**FINAL DRAINAGE REPORT
FOR
STERLING RANCH FILING NO. 5**

**December 2023
Project No. 25188.16
PCD Filing No: XX-XXX**

**Prepared By:
JR Engineering, LLC
5475 Tech Center Drive, Suite 235
Colorado Springs, CO 80919
719-593-2593**

STERLING RANCH FILING 5 EXISTING DRAINAGE MAP

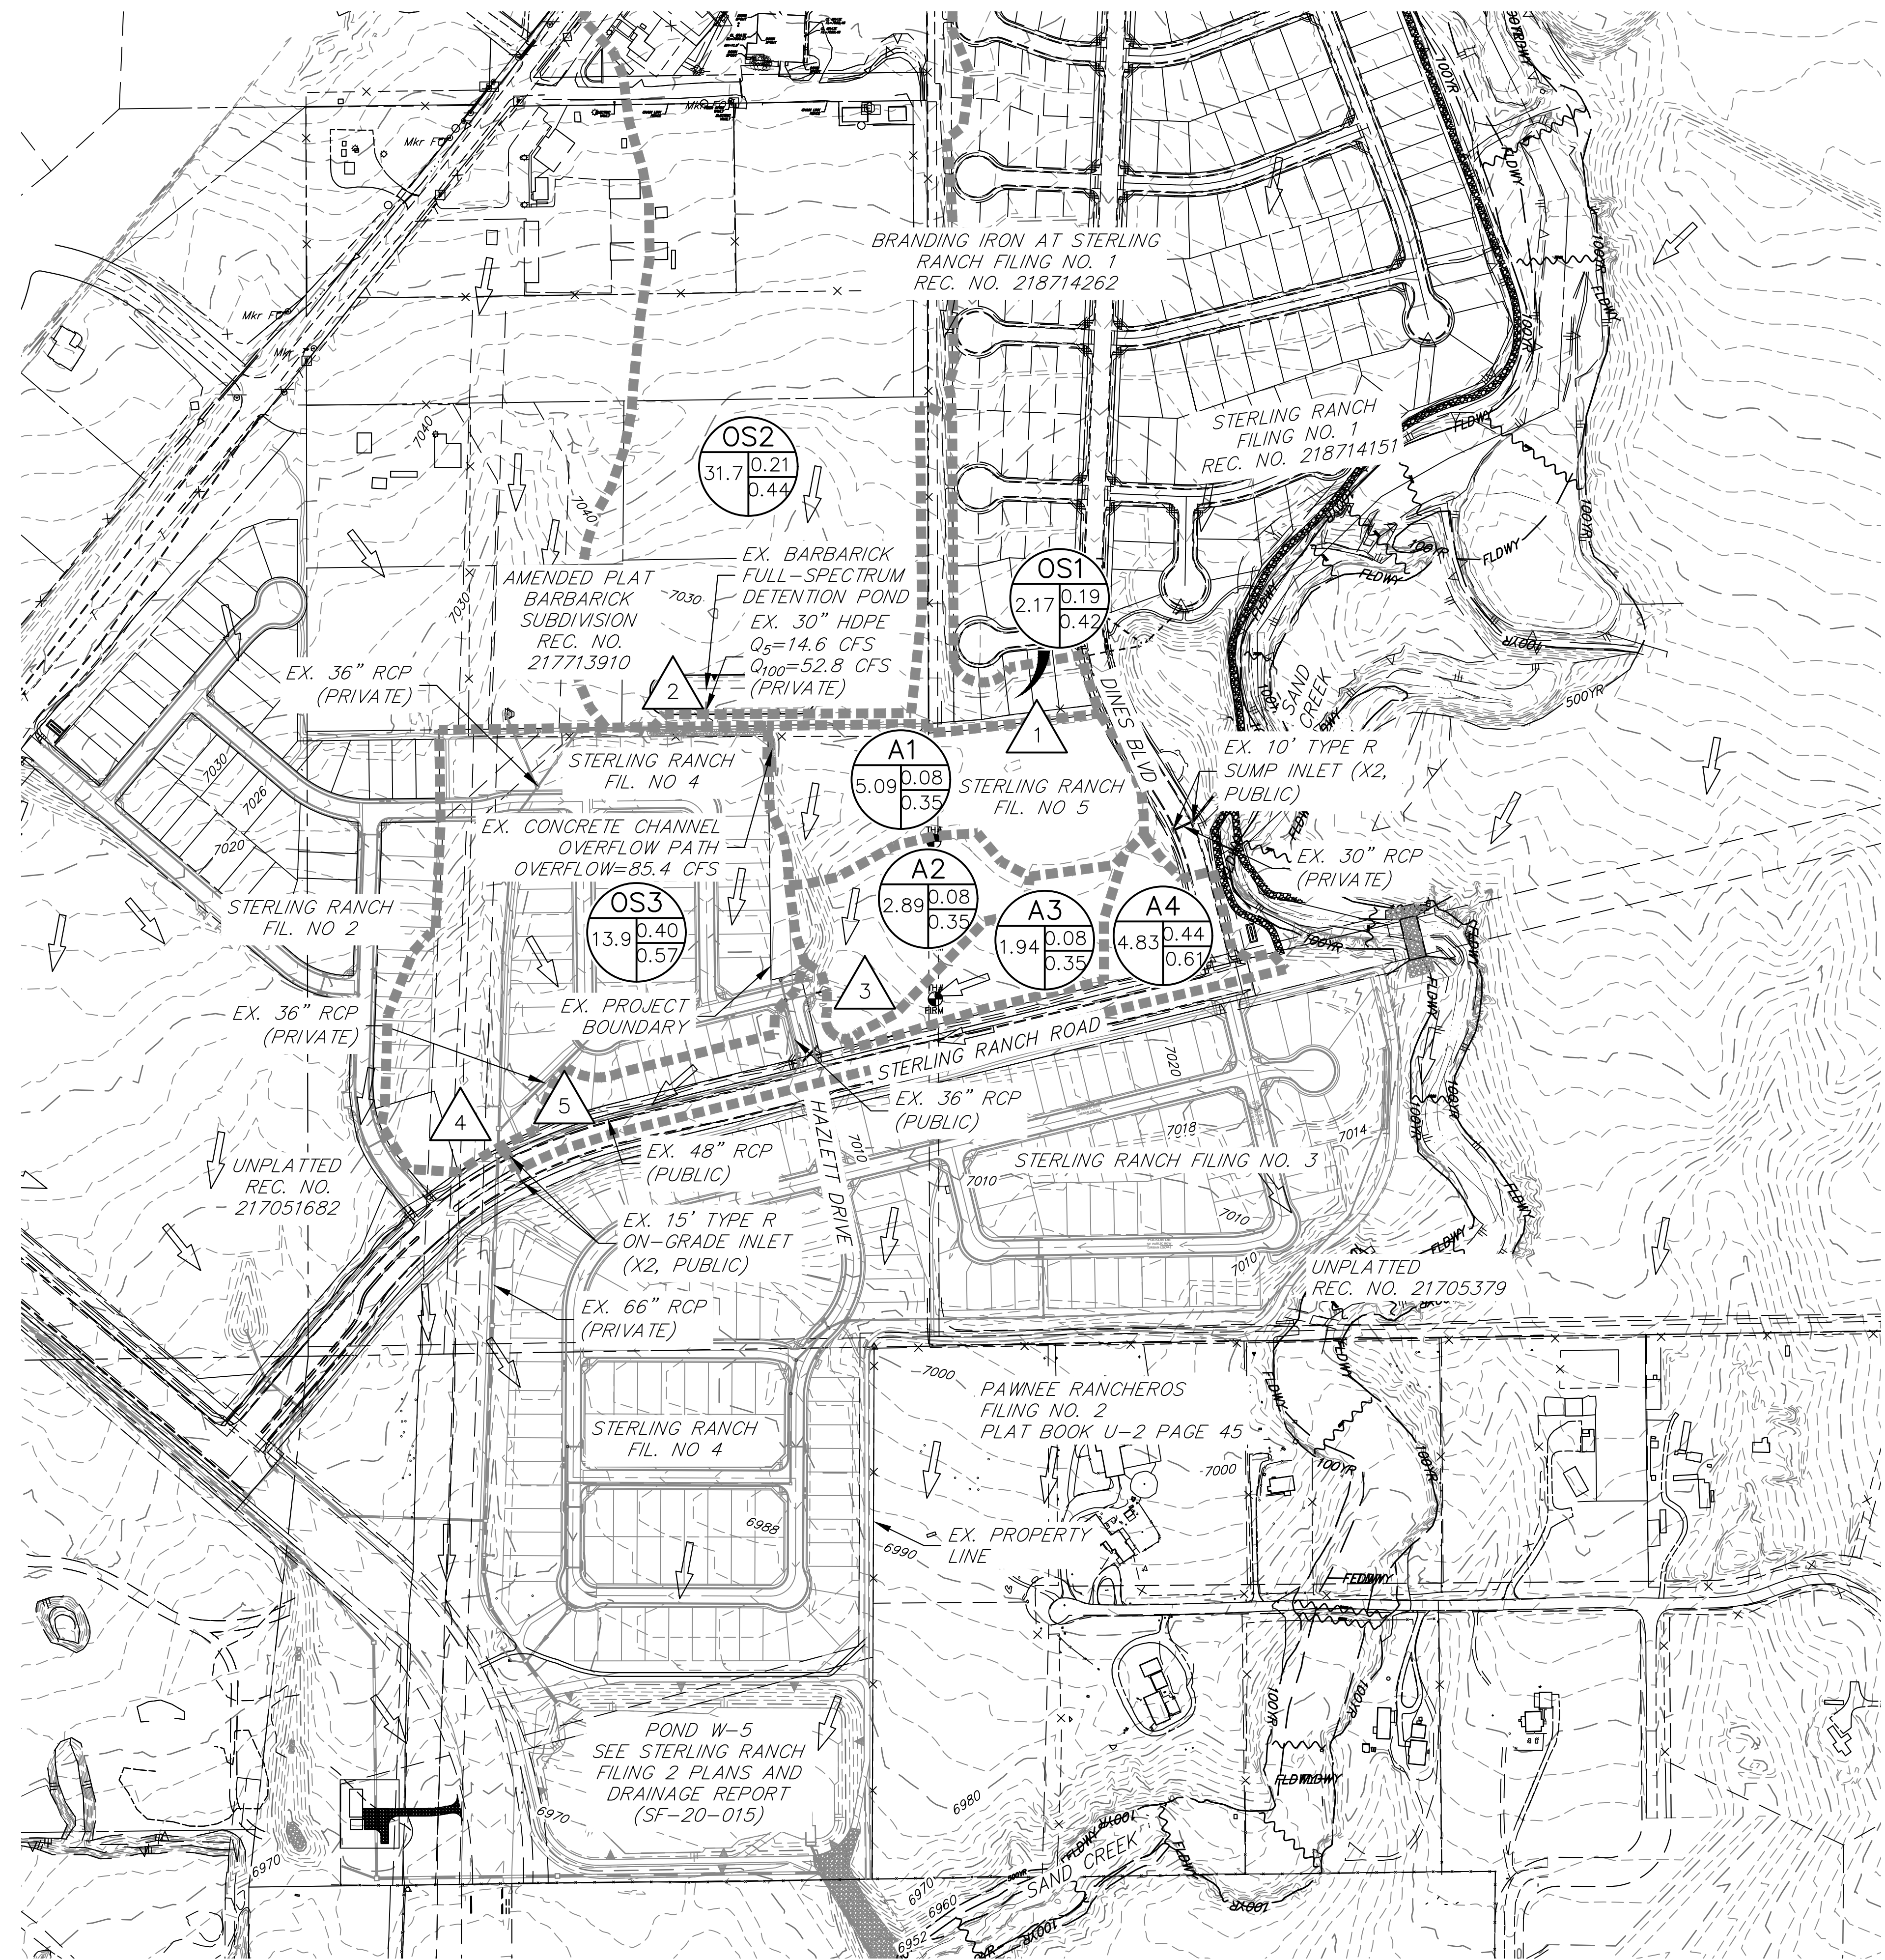
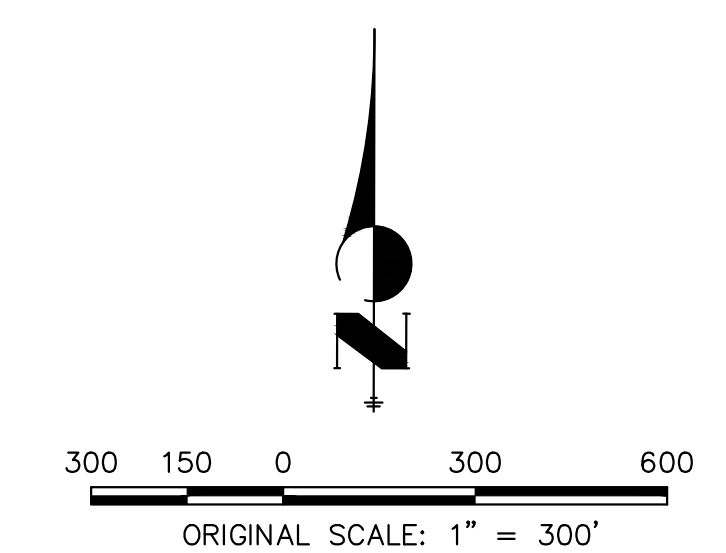
Flows don't match with design point flow in spreadsheet. Please update

JR Response: Addressed.

STERLING RANCH FILING NO. 5
PROPOSED DRAINAGE MAP
JOB NO. 25188.16
12/20/23
SHEET 1 OF 1

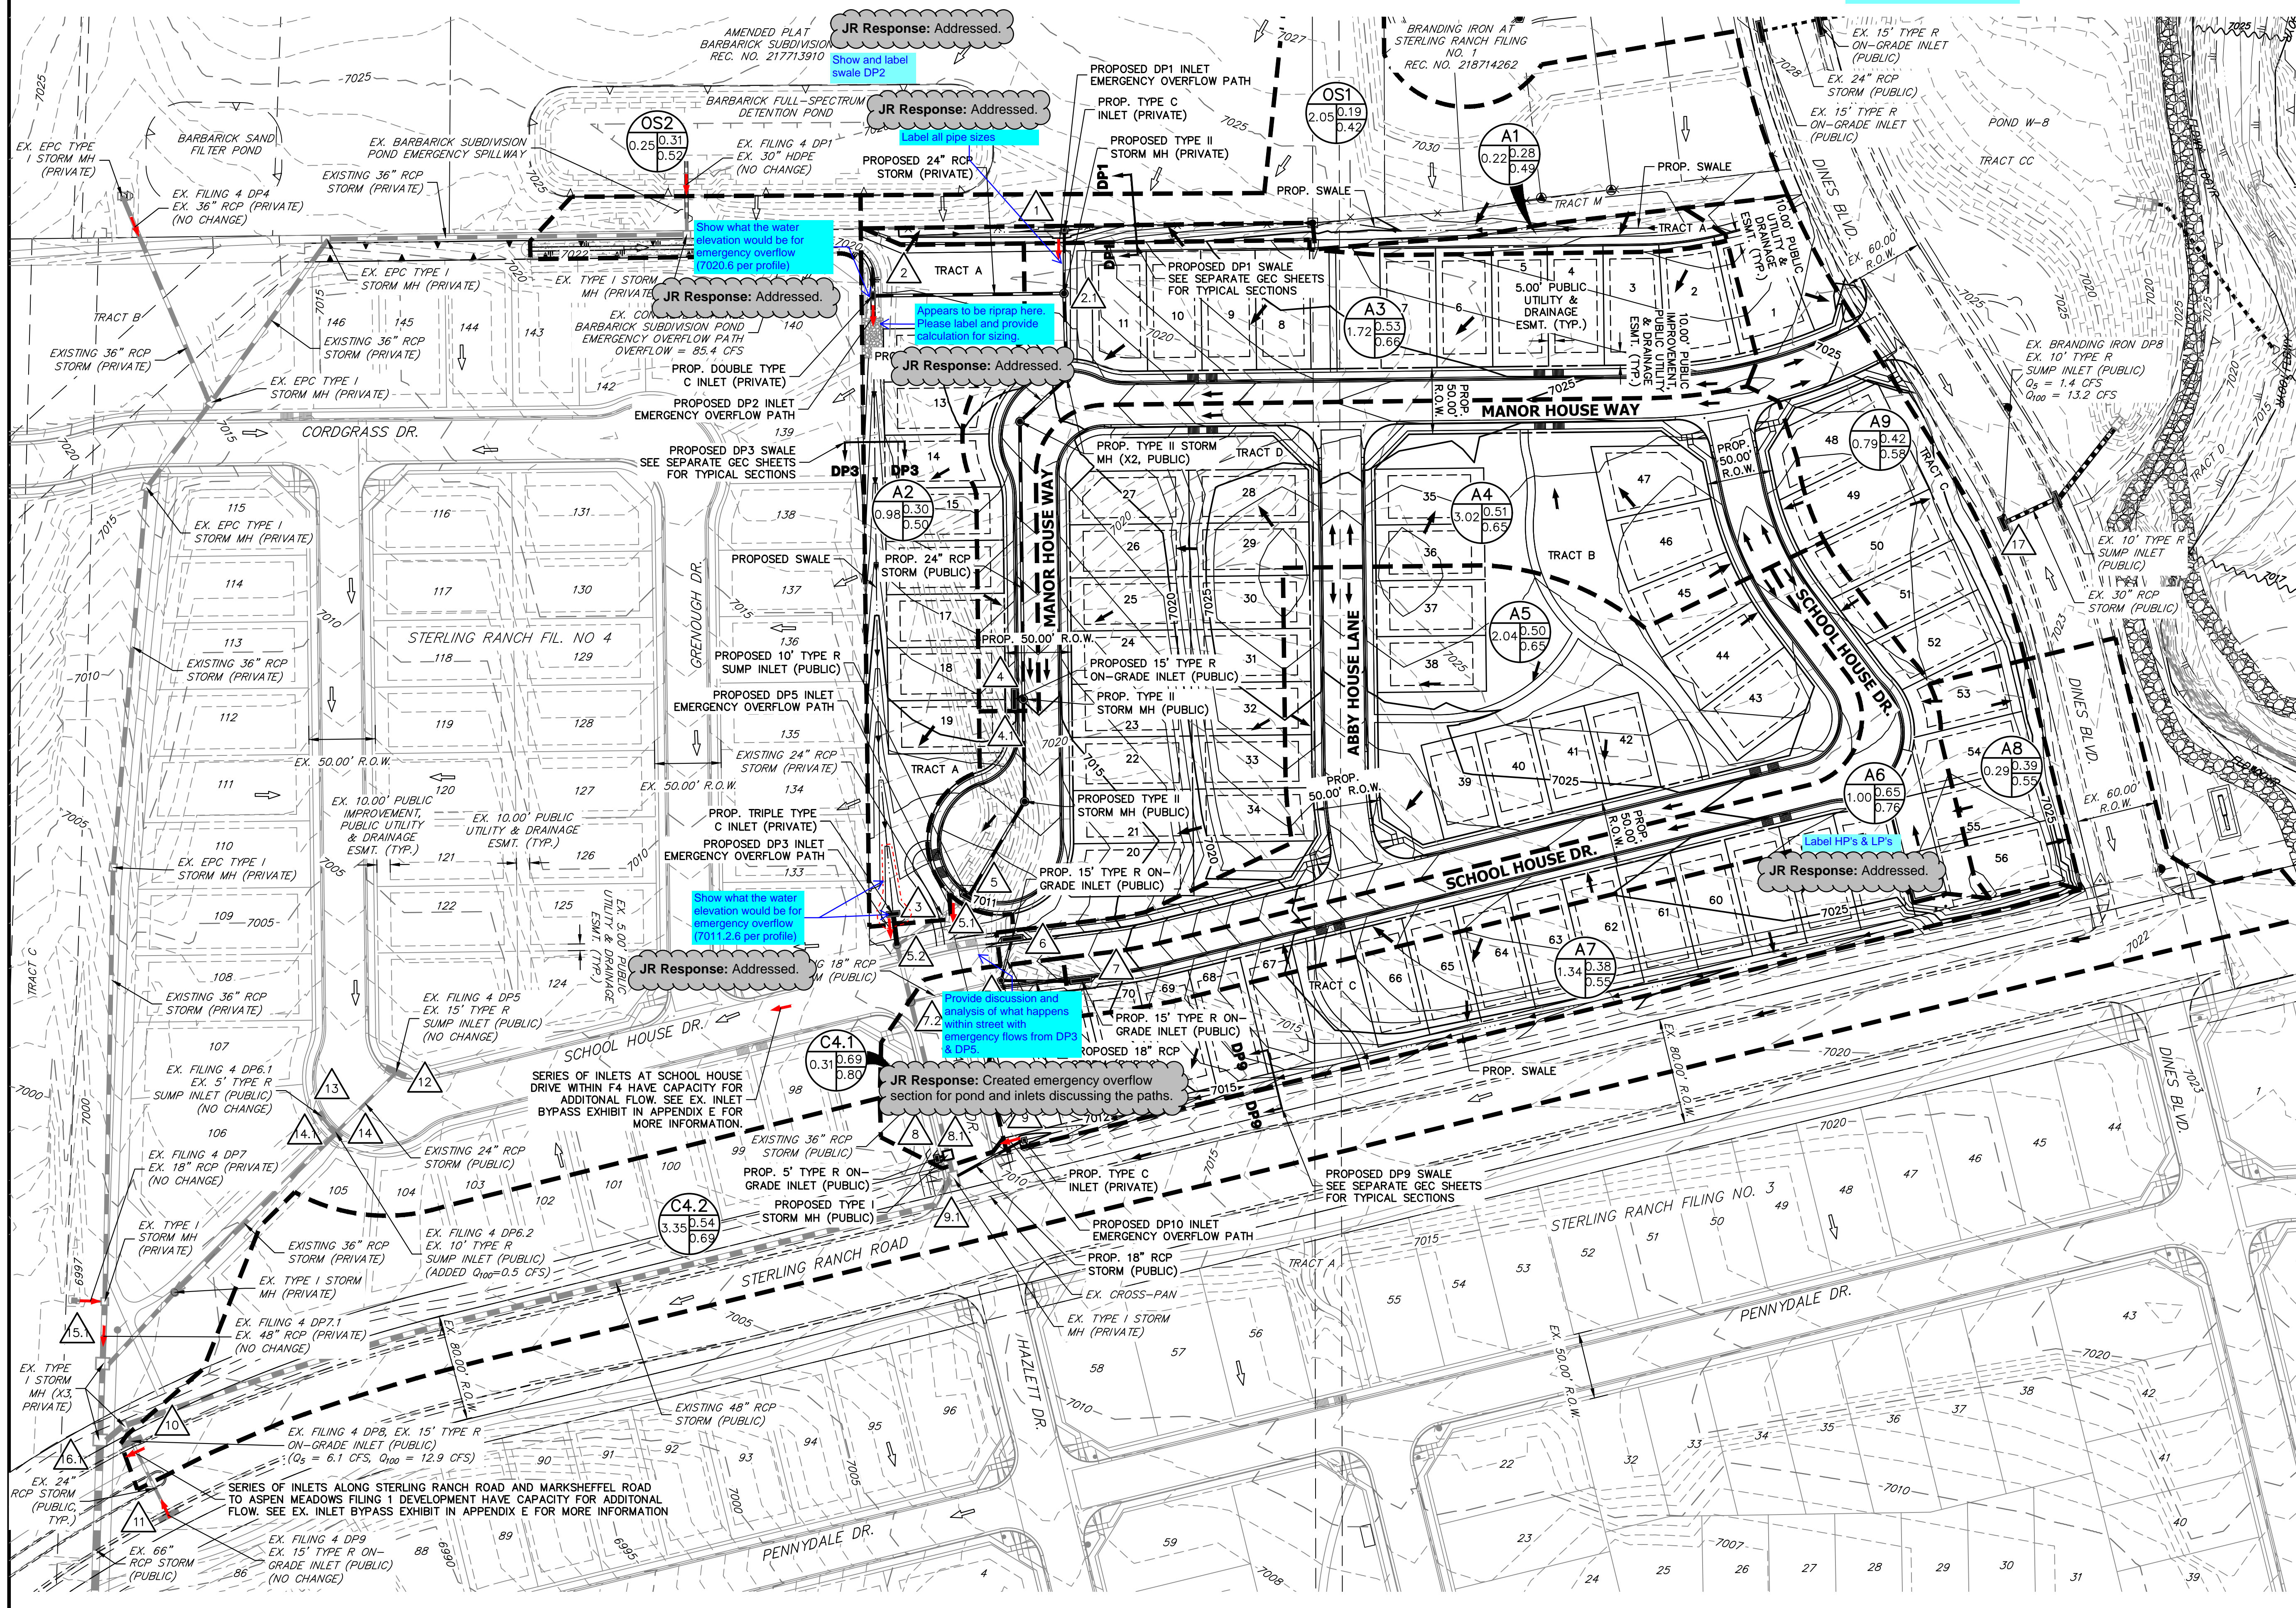
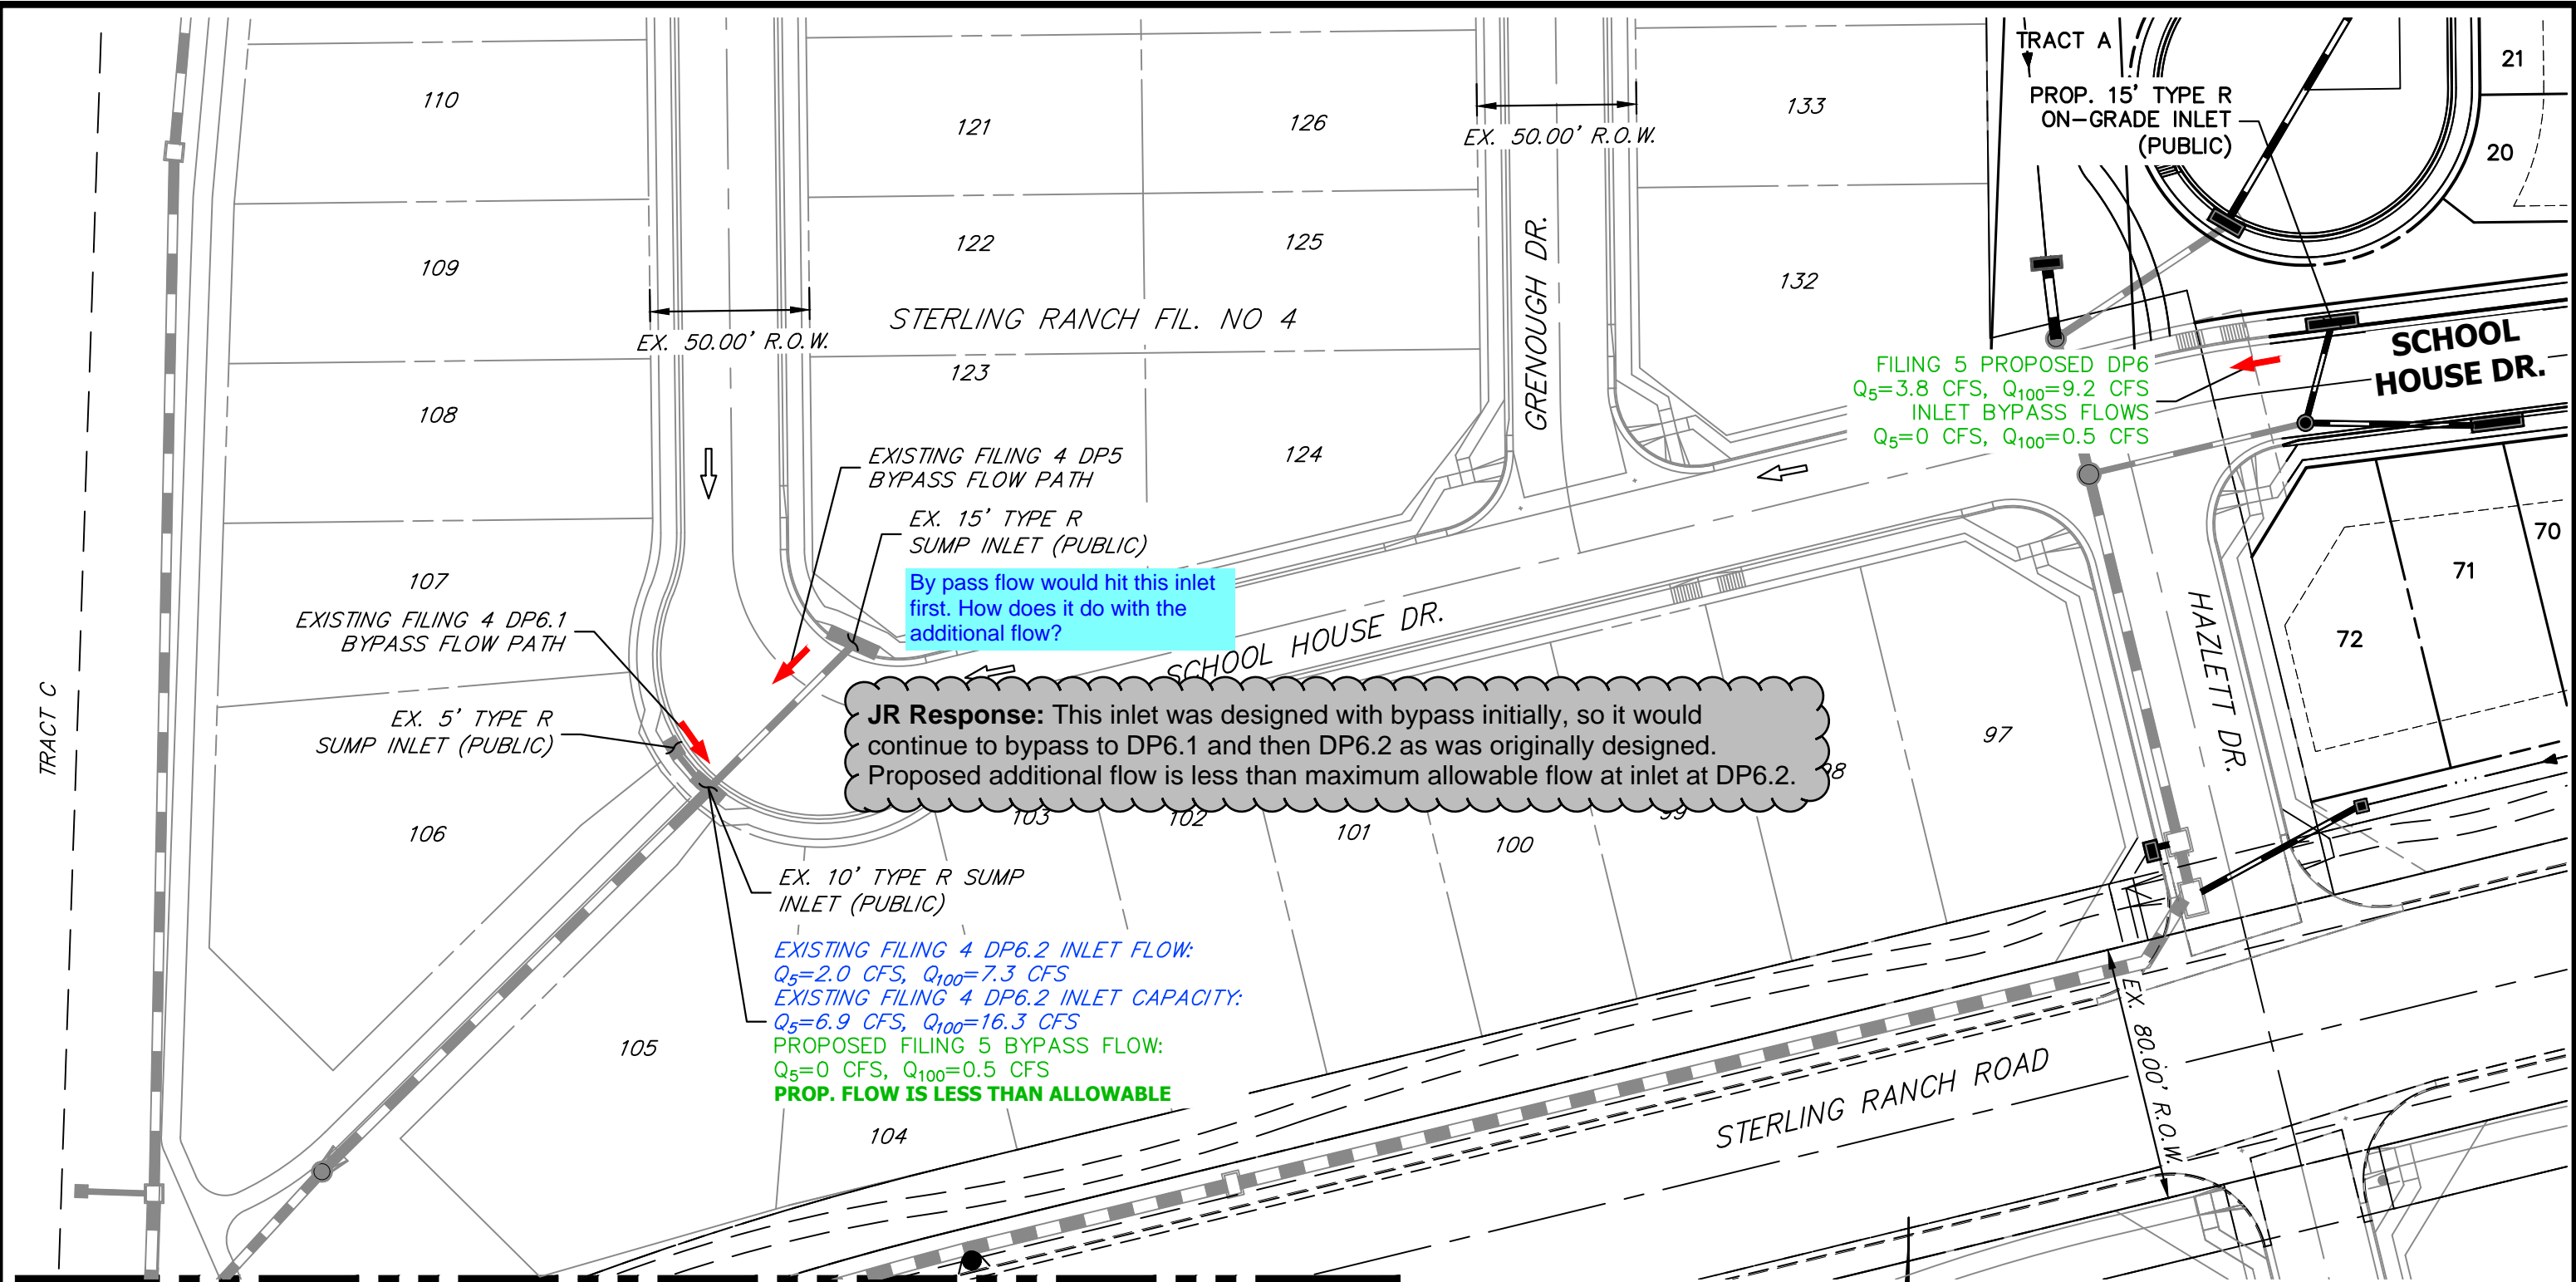
JR Response: Addressed.
Provide discussion and analysis of what happens within street with emergency flows from DP3 & DP5.

JR Response: Addressed.
